Product Change Notification

Date Issued :	May 19, 2023	PCN Number :	513631
Reason for Change :	Change to Product		
Description of Change :	This notification is to inform you about changes that are being made to the part(s) as identified in the list. This change will affect the Fit, Form, Function, or appearance of the parts. Or it may result in a change to the specification or raw material.		
Assessment of Change :	First Article Inspection		
Planned Implementation Date :	November 20, 2023		
Sample Availability Date:	October 13, 2023		
Internal Molex Qualification Date :	October 13, 2023		
Last date to request Samples by Customer :	October 13, 2023		
Traceability Code Markings / Date :	Date code

Before Picture

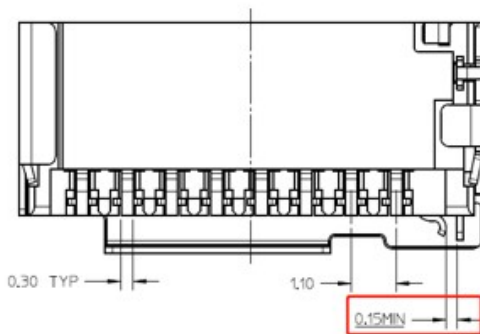
- Per simulated the tolerance analysis to optimize product tolerances

After Picture

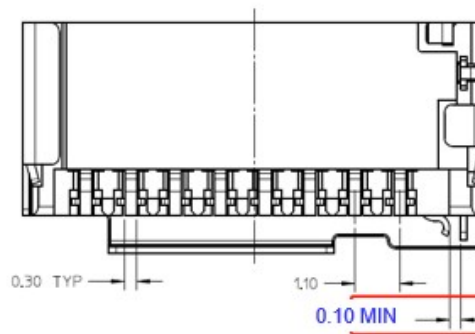
- Per simulated the tolerance analysis to optimize product tolerances

- Product Impact:
No impact to fit, form or function.
- Part Number Impact:
See attached impacted parts list
